ZON2011-00012

Kum & Go LC - 5830 and 5832 Southeast 14th Street

Communication from the City Plan and Zoning Commission advising that at their meeting held February 17, 2011, the following action was taken:

APPROVAL of a request from Kum & Go, LC represented by Charles Campbell (officer) for property located at 5830 and 5832 Southeast 14th Street Part A) to find the requested rezoning in conformance with the existing Des Moines' 2020 Community Character Plan; Part B) to approve the proposed rezoning to "PUD" Planned Unit Development District; and Part C) to approve the proposed Conceptual Plan, subject to the following modifications:
ZON2011-00012

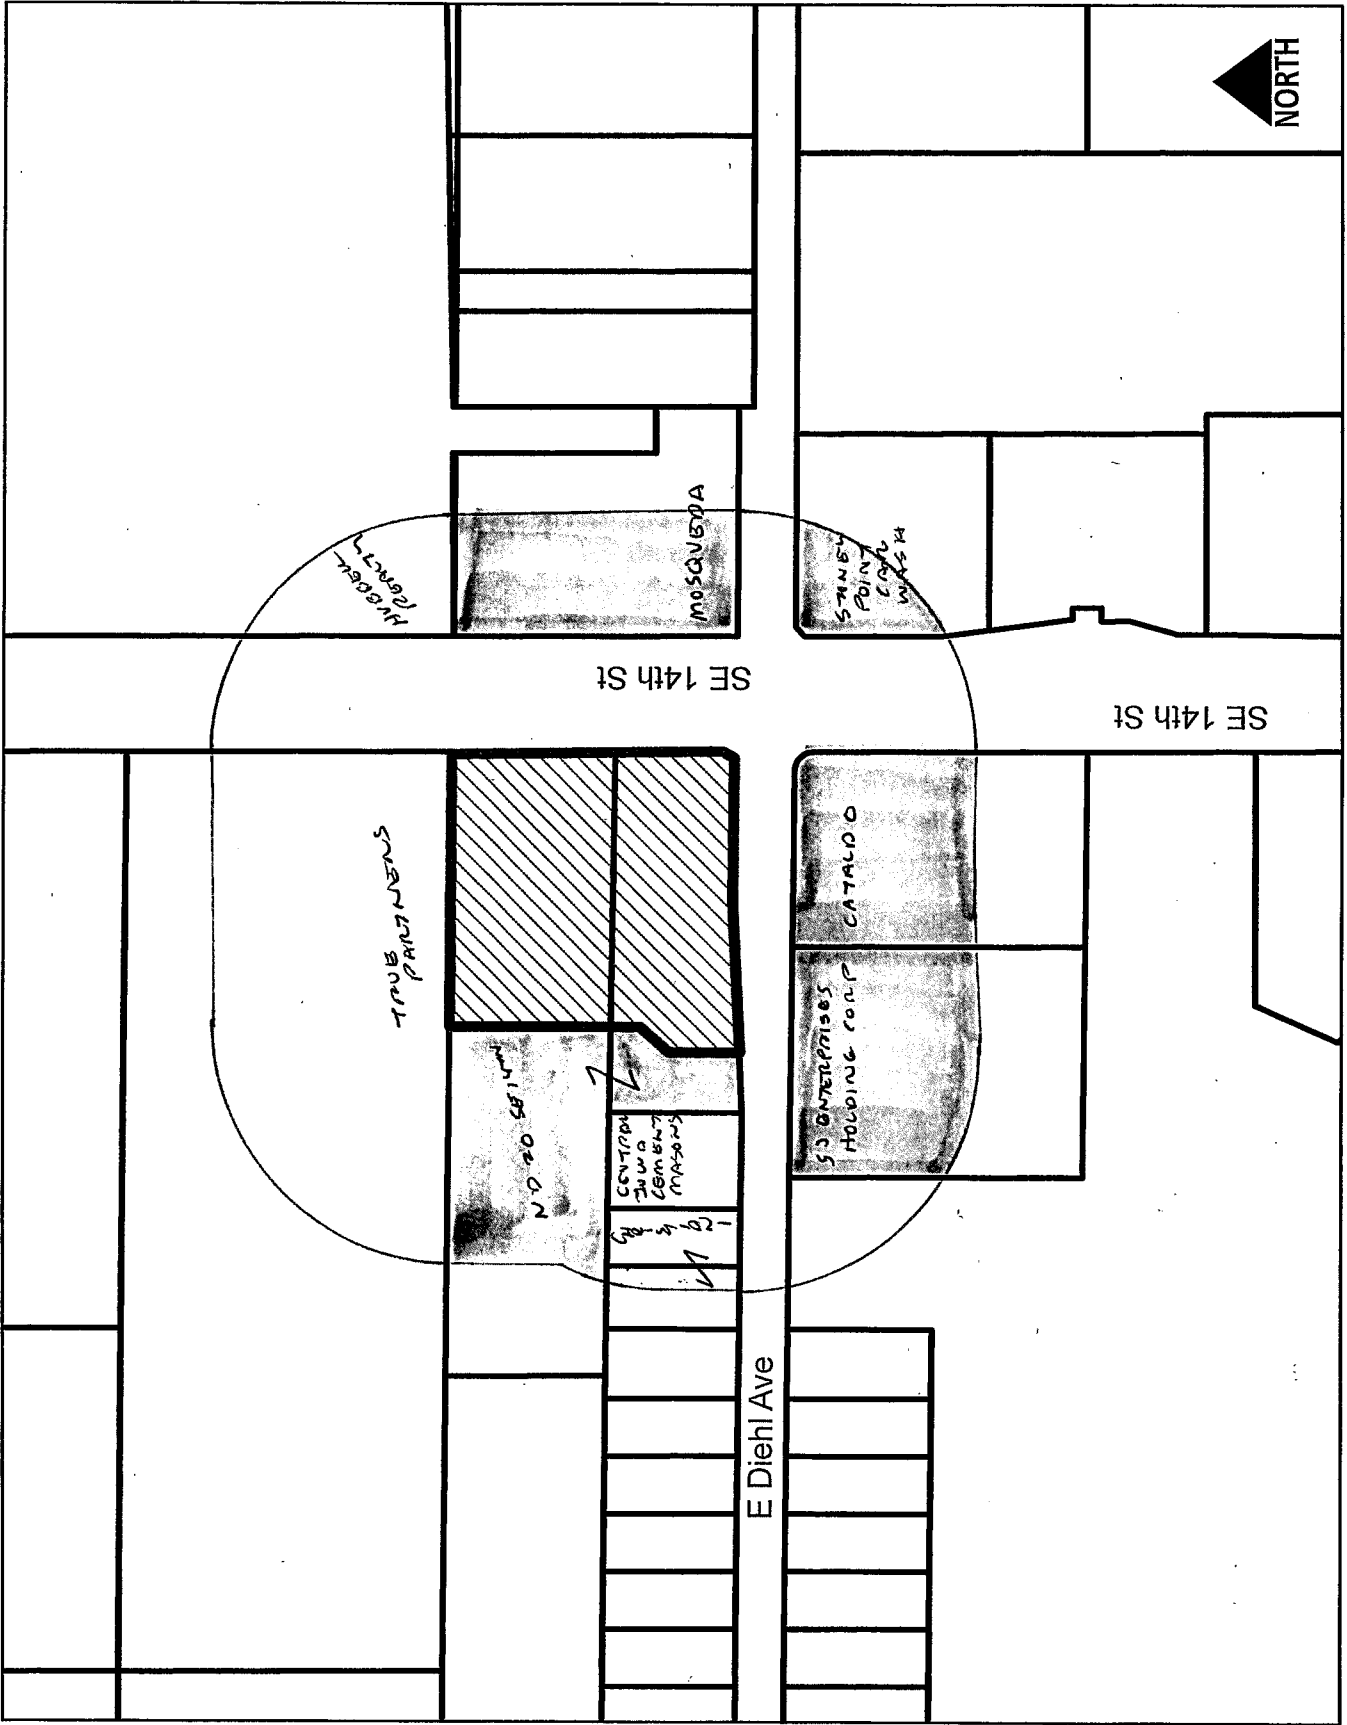
The proposed canopy would be sided with a metal material and supported by metal columns. Staff believes that the columns must be wrapped in masonry that matches the building for this guideline to be met.

The submitted Conceptual Plan indicates the canopy would be approximately 21 feet tall, including attached signage. Staff recommends that this be reduced to 18 feet to comply with the standard.

The submitted Concept Plan includes one monument style sign along Southeast 14th Street and one pole sign along East Diehl Avenue. Both signs would include a 10-foot by 5-foot (50 square feet) component and a 10-foot by 2.5-foot (25 square feet) component. Staff recommends that any freestanding sign on the site shall be the monument style sign with a masonry base to match the primary structure, rather than a freestanding pole sign.

The submitted information does not address lighting. Staff recommends that compliance these guidelines to the satisfaction of the Community Development Director be a condition of approval.

- 1) Provision of a note on the Conceptual Plan stating that any gas station/convenience store shall be developed in compliance with the City's Gas Station/Convenience Store Site Plan Design Guidelines (Section 82-214.8) as demonstrated at the Development Plan stage.
- 2) Elimination of the west drive entrance onto East Diehl Avenue since it would be too close to the median improvement that the City constructed as a result of the recent Menards expansion. The City's Traffic and Transportation Division has indicated that a commercial driveway would be permitted on the parcel to the west, which would allow for a second entrance onto East Diehl Avenue so long as necessary easements are secured.

- 3) Provision of cross-access easements for the adjoining neighborhood commercial properties both to the north and to the west.
- 4) The driveway approach radius along Southeast 14th Street shall not extend beyond the adjacent property line without an agreement with that owner.

- 5) The fuel canopy shall not exceed 18 feet in height. However, oval-shaped signage on the canopy shall be permitted to have a maximum height of 20 feet 4 inches.

- 6) The bottom 6 feet of the fuel canopy columns shall be wrapped with masonry material that matches the primary building. The balance of the columns shall be painted a taupe color.

- 7) A note shall be added to state that all roof top mechanical equipment shall be screened by the building's parapet wall or other material as approved by the Community Development Director.

- 8) Any dumpster enclosure shall be constructed with masonry material to match the primary structure and shall have gates constructed with a steel frame and "Trex" material.

- 9) One freestanding sign shall be permitted on the site, which shall be a monument style sign with a masonry base to match the primary structure.
- 10) The PUD Conceptual Plan shall identify the location of propane tanks for sale and a movie rental machine (such as RedBox) along the east side of the building. A note shall be added to state that all other display items for sale, excluding seasonal items (i.e., sand, salt, pop, firewood) shall be located within the main building. All outdoor display of seasonal items shall be identified on the Development Plan and be located outside of any required setbacks. No display of seasonal items shall exceed 5 feet in height.

- 11) A note shall be added to state that all site lighting will be in compliance with the lighting standards of City Code Section 82-214.8 to the satisfaction of the Community Development Director.
